66321D-07

S E R V I C E N O T E

Agilent 66321D DC Power Supply

On faster computers, when programming over GPIB, a random error will occur.

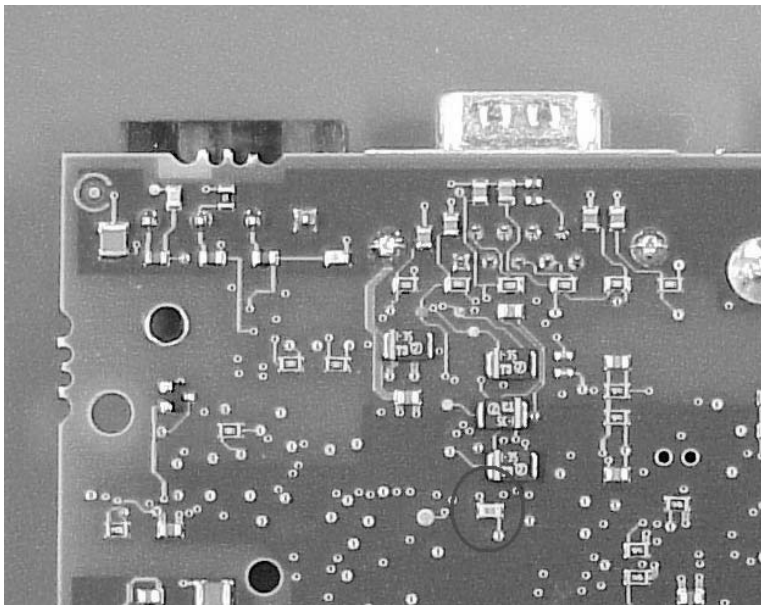
When programming a unit over GPIB, a random error -113 (“Undefined header”) will appear on the unit. This error can be read back via the front panel or over the GPIB bus.

Change resistor R1246 (see picture for location) from 511 Ohms to 100 Ohms (part number 0699-3058). This requires soldering a surface mount component and can be very difficult. This does not require re-calibration.

Replace the entire GPIB assembly (part number 5063-4841) with a newer one that has the 100 Ohm resistor. This will require the unit to be re-calibrated.
